CITY OF VINCENT

AGENDA
Late Reports
Council Briefing
24 April 2018

5 DEVELOPMENT SERVICES**5.7 LATE REPORT: NO. 48 (LOT: 66; D/P: 6049) MILTON STREET, MOUNT HAWTHORN - PROPOSED FIVE GROUPED DWELLINGS**

To consider an application for development approval for five Grouped Dwellings at No. 48 Milton Street, Mount Hawthorn (subject site).

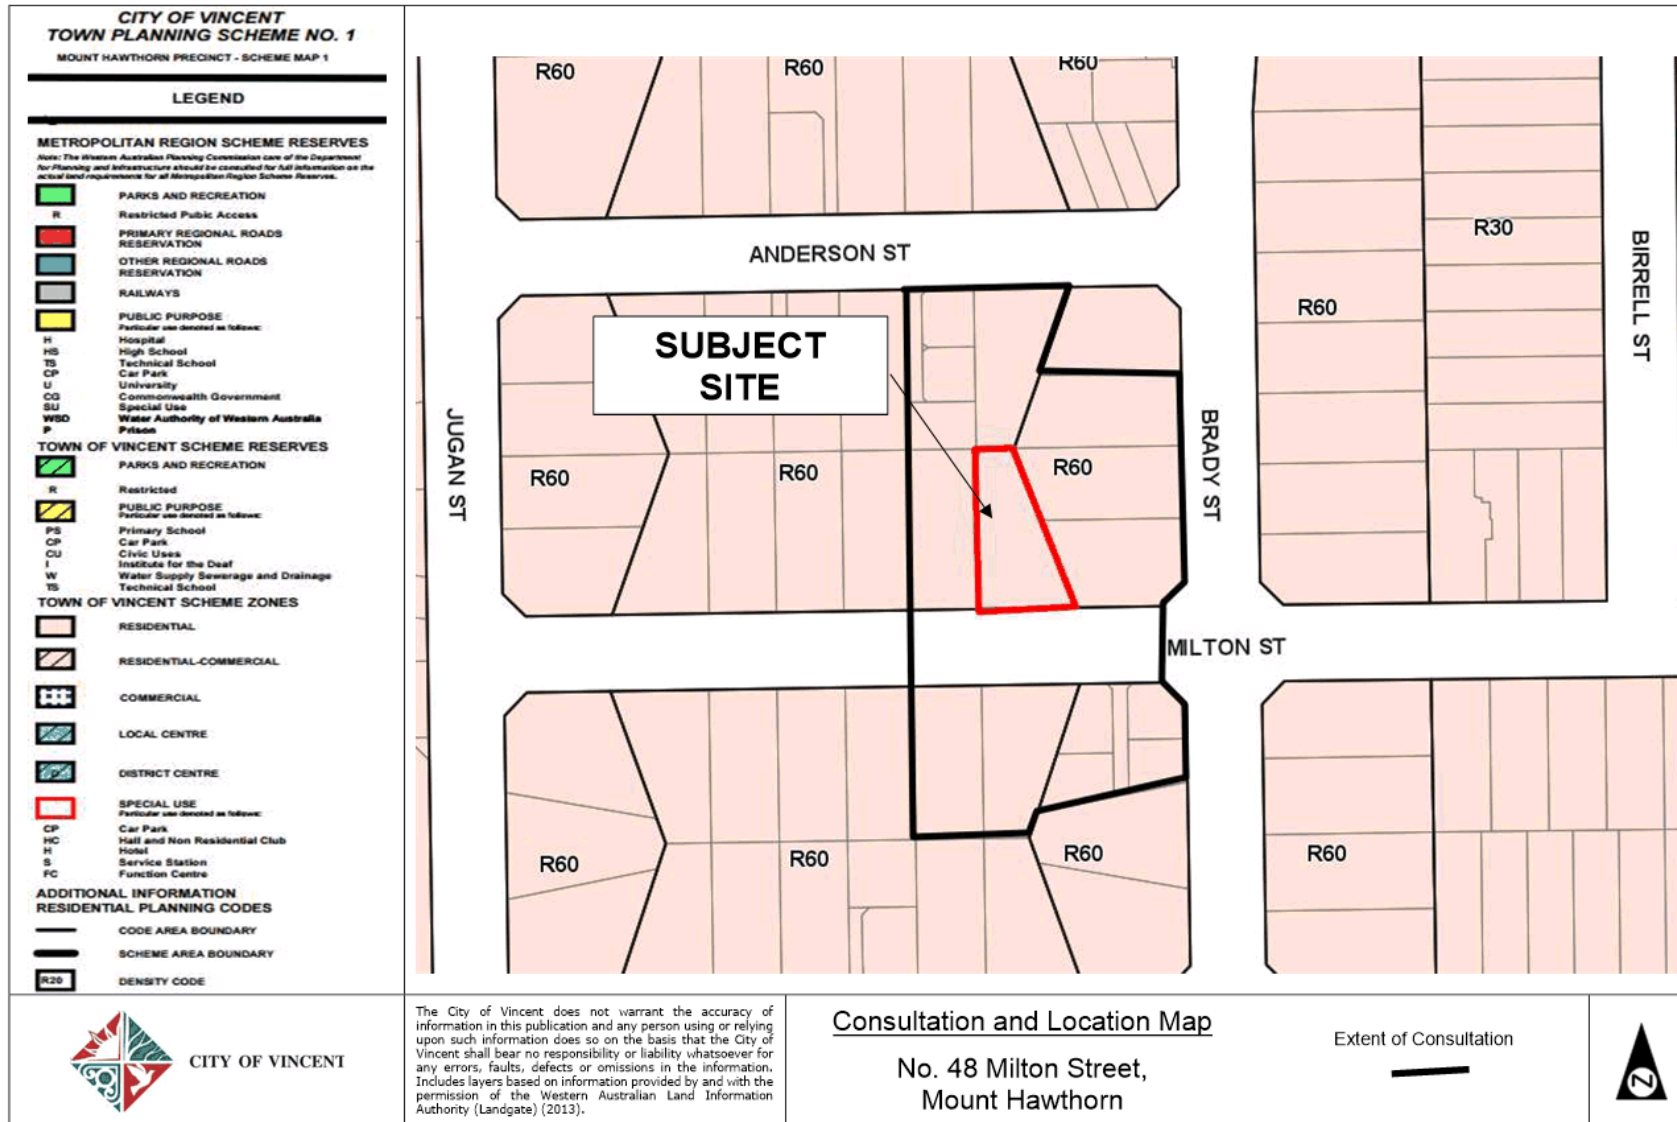
Unit B, C and D propose outdoor living areas that do not meet the minimum dimension of 4 metres by 4 metres in accordance with the deemed-to-comply criteria of the Residential Design Codes. Although the outdoor living areas are capable of use in conjunction from a habitable room, the total area provided is considered to limit the enjoyment and potential of outdoor living pursuits. It is further noted that the outdoor living areas exceed permanent roof cover which provides an impact with regard to dwellings being open to direct sun.

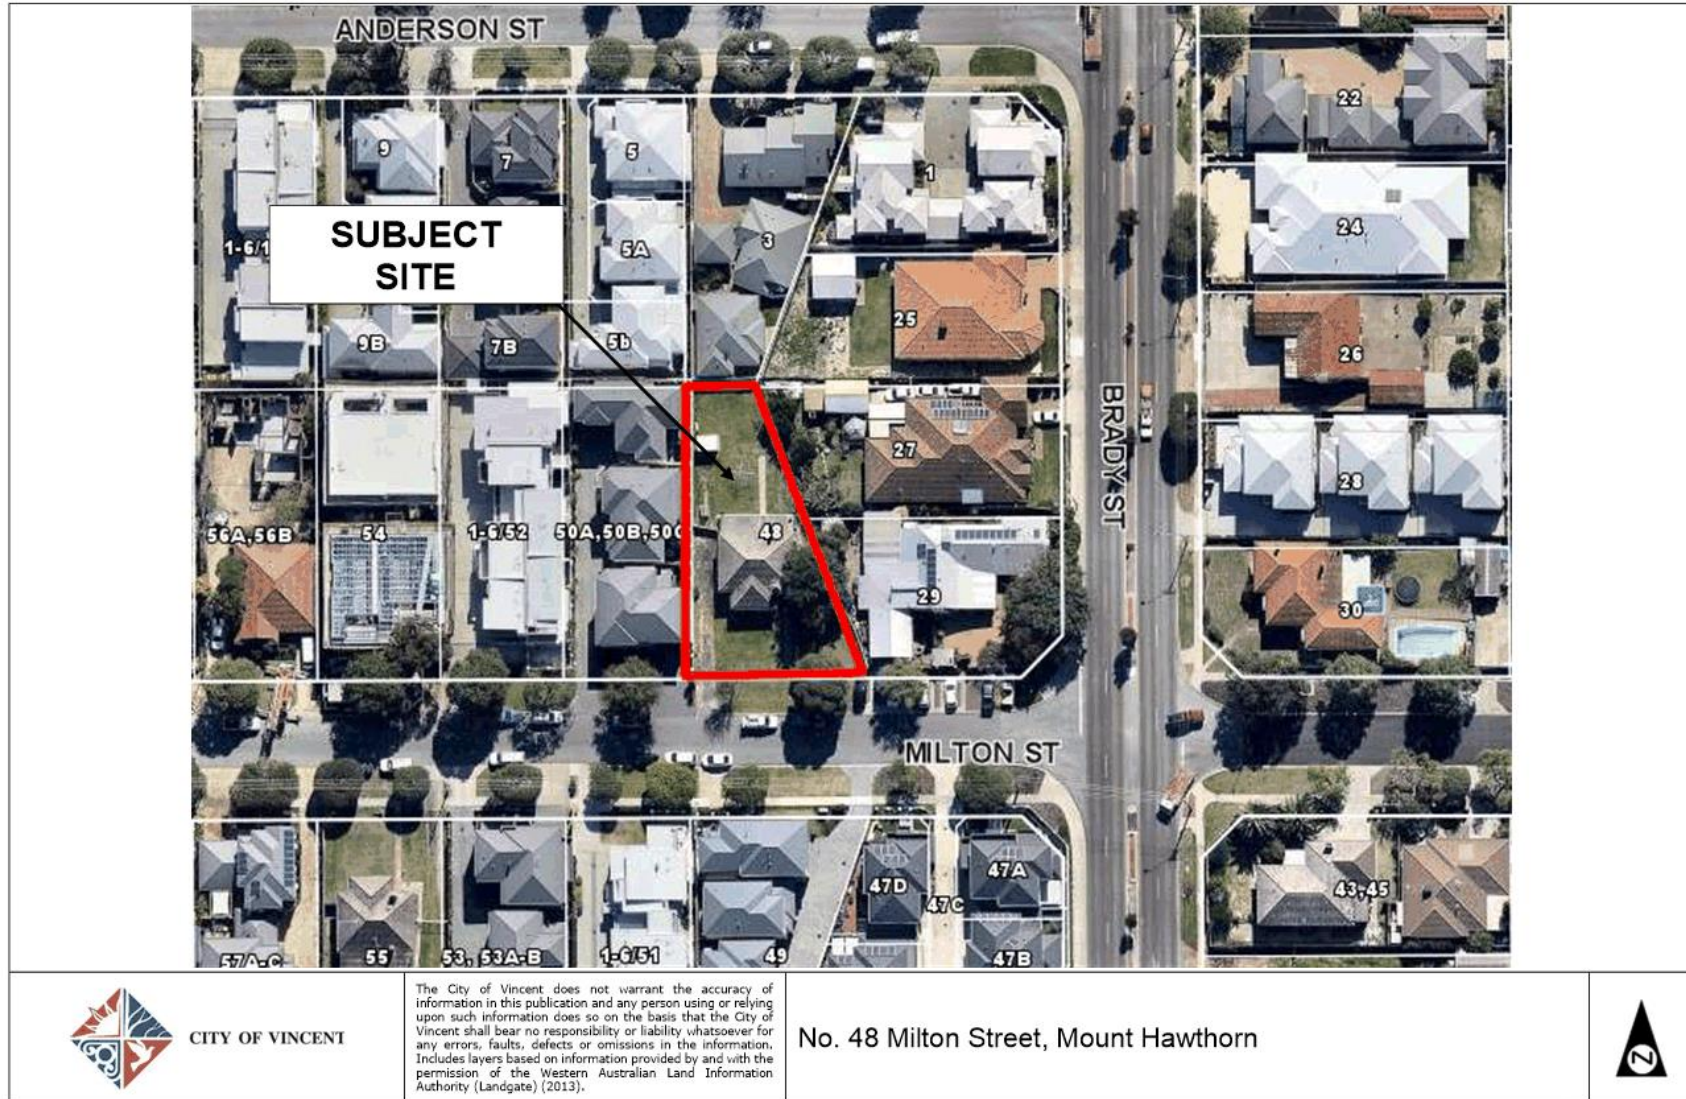
The outdoor living area of Unit B in particular proposes an outdoor living area dimension of 3.7 metres by 3.3 metres, is 100 per cent covered by permanent roof and is partially proposed within the front setback area adjacent the common property driveway. The outdoor living area will not be open to winter sun given the full extent of permanent roof coverage proposed. The lack of open outdoor living areas is not considered to assist with reducing building bulk to the site or cater for attractive settings between buildings and landscaping. The site is considered to be over developed, particularly given the minimal outdoor living areas proposed for each unit with due regard to the nil setbacks proposed from each individual unit and the minimal setbacks proposed to the north and eastern lot boundaries. The minimal open space between each individual unit provides limited means of capturing winter sun for the outdoor living areas and habitable spaces of the dwellings. The site is considered to provide significant opportunity in achieving access to natural sunlight for the dwellings and is therefore considered to not contribute in providing an attractive setting for the units proposed.

Ground Floor Plan
scale 1:100

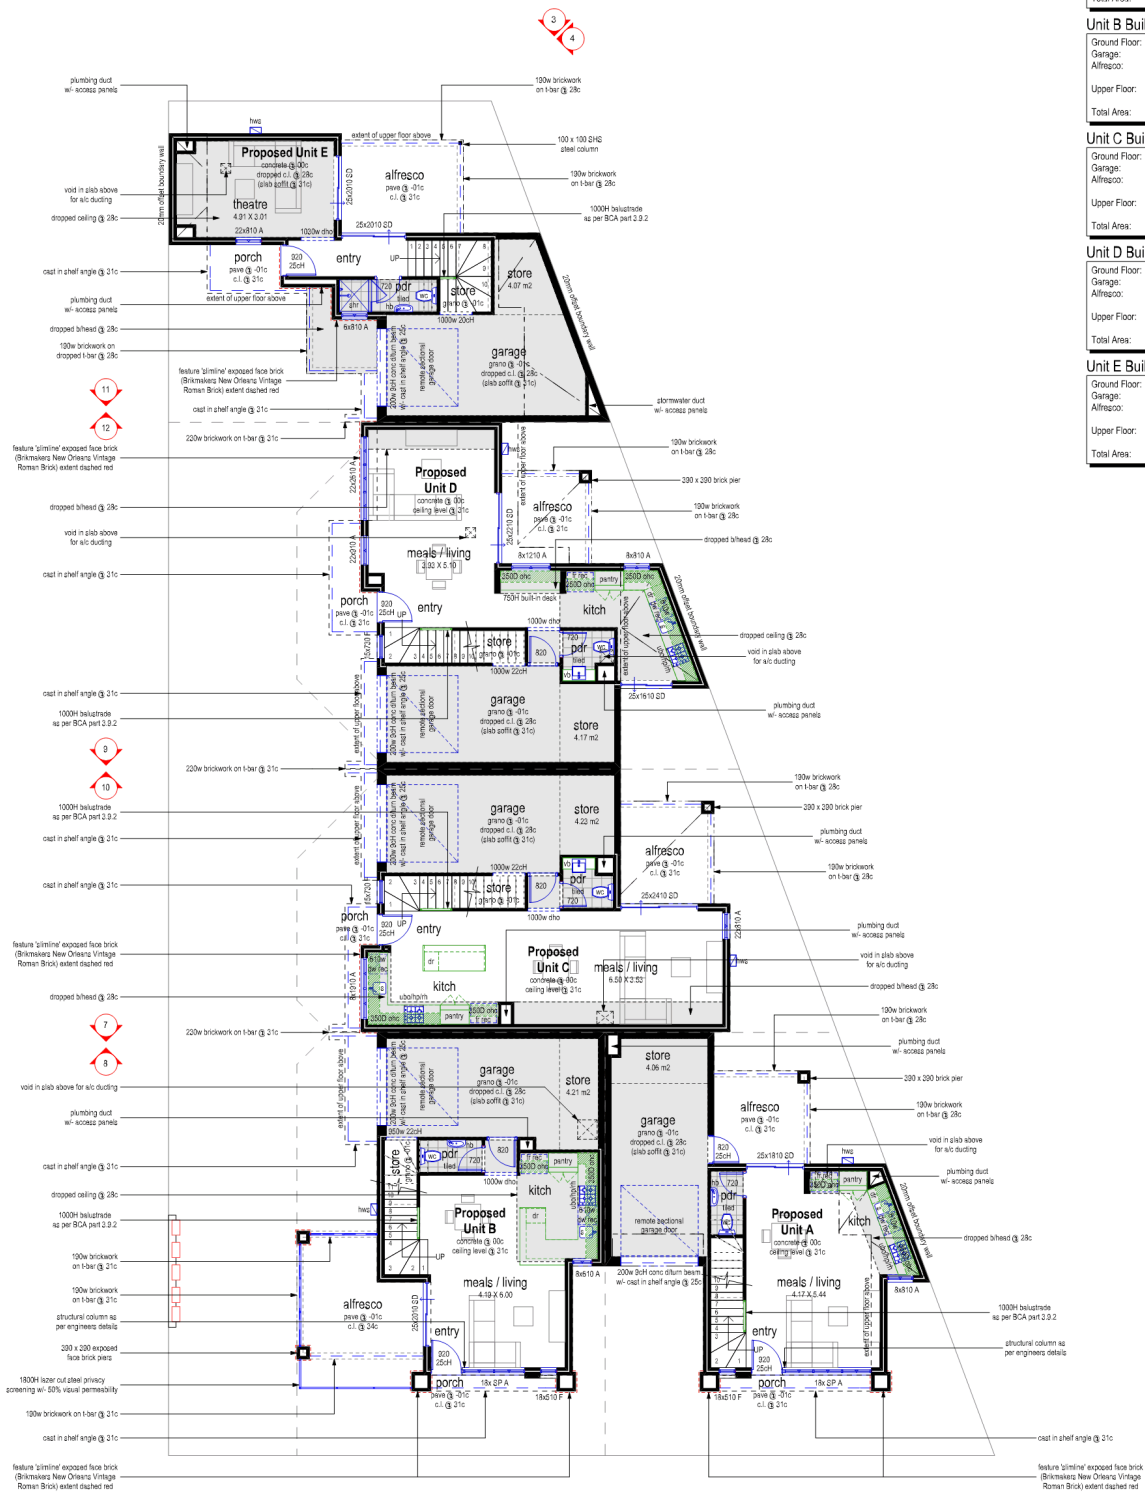
The development encroaches into the street setback area which is considered to add to the perception of building bulk to the streetscape. As such, it is considered that the development does not preserve and enhance the visual character of the existing streetscape by considering existing building setbacks. The reduction of the street setback area is also considered to reduce the ability to accommodate additional landscaping in the front setback area which would assist to reduce the perception of a single continuous dwelling given the lack of separation between Unit A and B.

The ground floor and upper floor setback of Unit A propose a 1.213 metre setback from the eastern lot boundary in lieu of a required 1.5 metre setback from the ground floor and a 3.2 metre setback from the upper floor. Unit C proposes a ground floor setback of 1.097 metres in lieu of a required 1.5 metres and an upper floor setback of 1.742 metres in lieu of 2.8 metres. Unit D proposes a 1.078 metre ground floor setback and a 1.244 metre upper floor setback in lieu of a 1.5 metre setback and Unit E proposes a 1.296 metre ground floor setback and a 1.217 metre upper floor setback in lieu of a 1.5 metre setback.

With regard to the northern lot boundary setback, Unit E proposes a 1.013 metre ground floor setback in lieu of 1.5 metres and a 1.213 metre setback in lieu of a 3.2 metre setback to the upper floor. The walls addressing the northern lot boundary are fully rendered and do not propose any varying material to help minimise building bulk to the neighbouring property. Given the minimal setback provided, no integration of landscaping is considered between the building and the lot boundary to address the impact of development on adjacent residential properties.

Unit A proposes a building on the eastern lot boundary to No. 29 Brady Street with an average wall height of 3.25 metres which exceeds the deemed-to-comply requirement of a 3 metre average wall height on the lot boundary. Unit D proposes an average wall height of 3.1 and Unit E proposes an average wall height of 3.2 metres which both adjoin the outdoor living area and open space of No. 27 Brady Street. The proposed buildings on the boundary coupled with the proposed reduced lot boundary setbacks and scale of the entire development are considered to negatively impact on the amenity and prevailing development of the locality and do not provide an attractive setting for the adjoining dwellings.

The wall on the west lot boundary proposes a maximum height of 3.6 metres with an average wall height of 3.45 metres. The wall is positioned abutting the neighbouring properties existing wall and is not considered to pose an undue impact on the adjoining neighbouring property.

DRAWING
LANDSCAPE PLAN

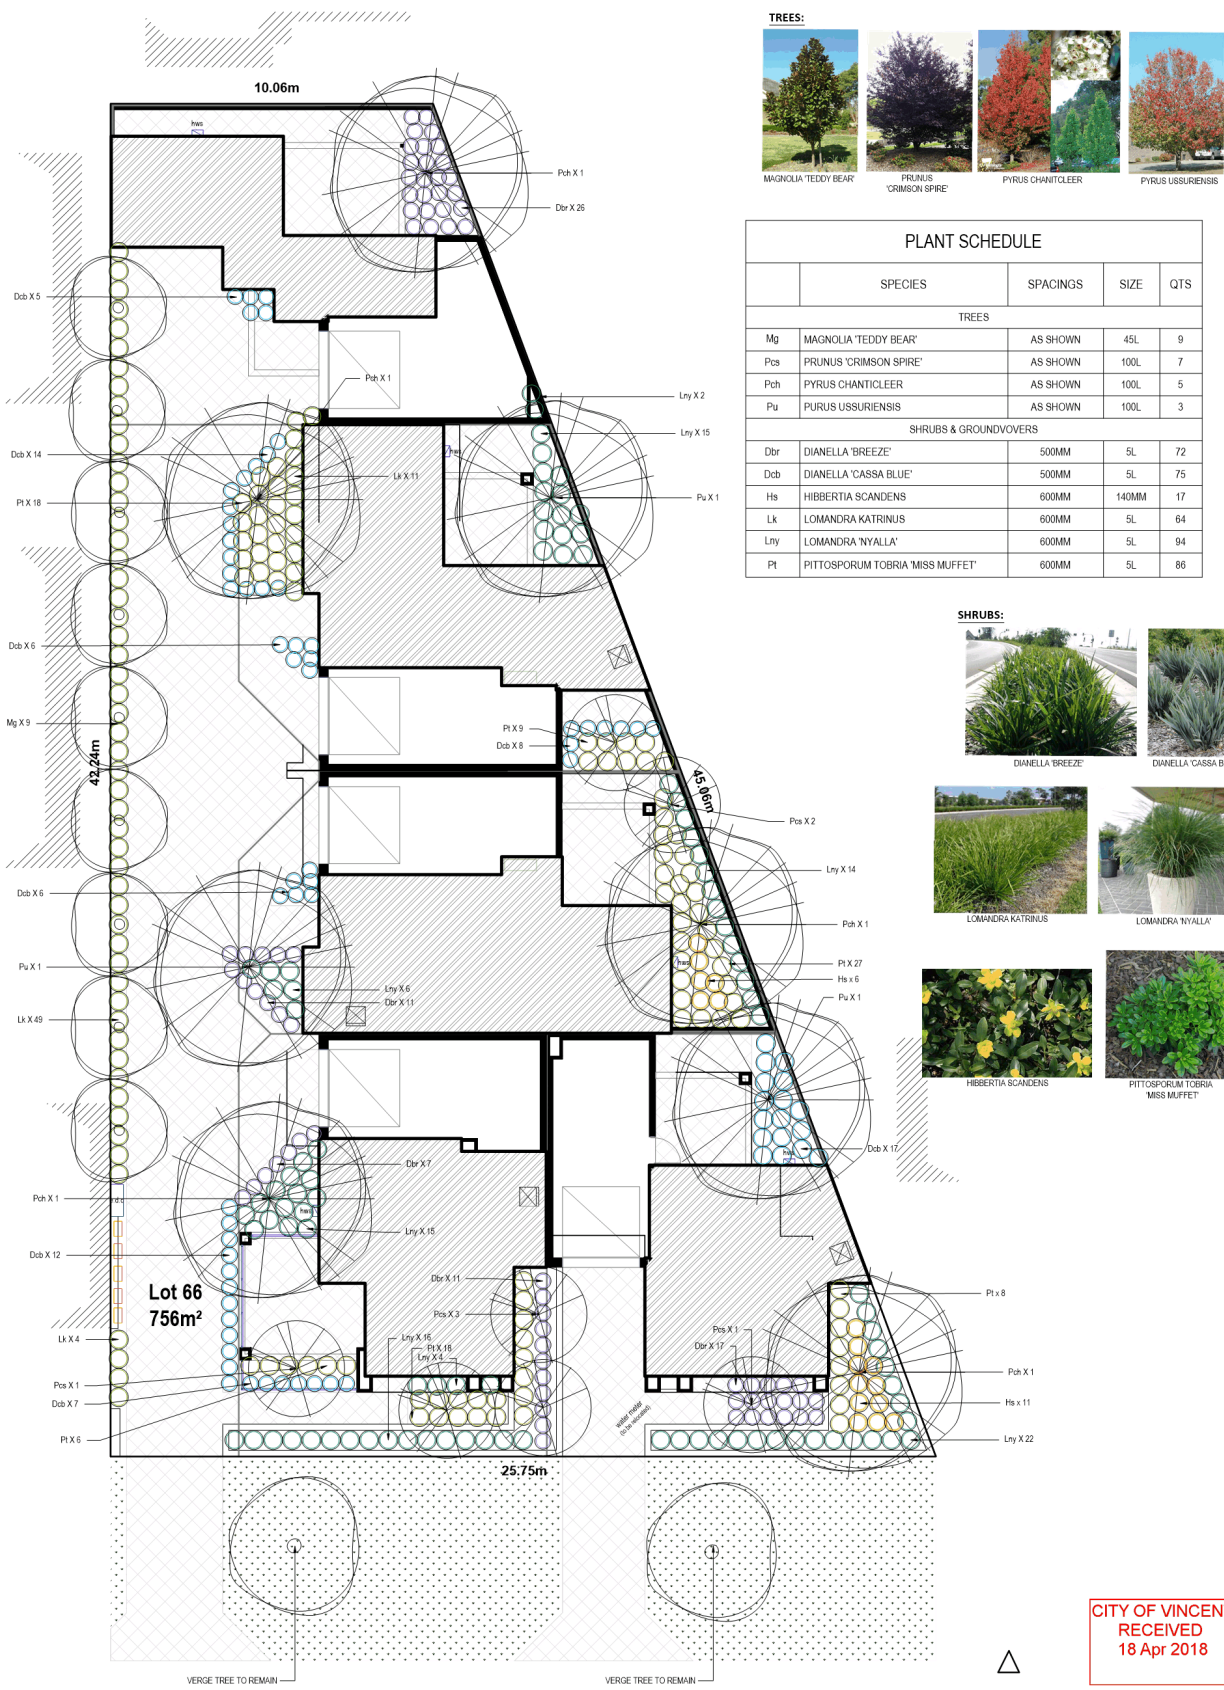
<p><u>Landscaping</u> A reduction in the landscaping requirement will have pose a visual impact on the streetscape and surrounding development.</p>	<p>The applicant proposed an amended landscaping plan which proposes a deep soil zone of approximately 12 per cent of the site and a tree canopy coverage of approximately 36 per cent of the site at full maturity. The deep soil zone does not meet the deemed-to-comply criteria of the City's Built Form Policy and the proposal does not provide added opportunity for landscaping to be designed to reduce the impact of development on adjoining properties.</p>
<p><u>Building on the Boundary</u> The building on the boundary of Unit E to the west lot boundary will impact the adjoining properties outdoor living area with regard to direct sun and overshadowing. The proposed white walls will reflect into the outdoor living area and be unusable.</p>	<p>The proposed building on the boundary of Unit E to the west lot boundary will abut the neighbouring properties dwelling which is approximately one metre from the lot boundary. The neighbouring properties outdoor living area will be adjacent the common property driveway of the subject development.</p>

<p>Principle 2 – Landscape quality</p>	<ul style="list-style-type: none"> • Provide more detail on the landscaping proposed to demonstrate compliance with City’s landscaping requirements (such as canopy cover, deep soil zone). • Landscaping is considered fragmented and ineffective. Certain areas are too narrow to be considered in landscaping calculations.
<p>Principle 3 – Built form and scale</p>	<ul style="list-style-type: none"> • Examine incorporating smaller and strategic areas of 3 storeys, where the impact to street and neighbours will be minimal, and moving the setbacks further from the boundaries to comply with the City’s policies and create opportunities for more landscaping. It will also ease pressure on the ground level allowing more usable landscaping and offer better ventilation across the site and immediate neighbourhood. Increasing the development to 3 storeys would give residents street views and provide passive surveillance.
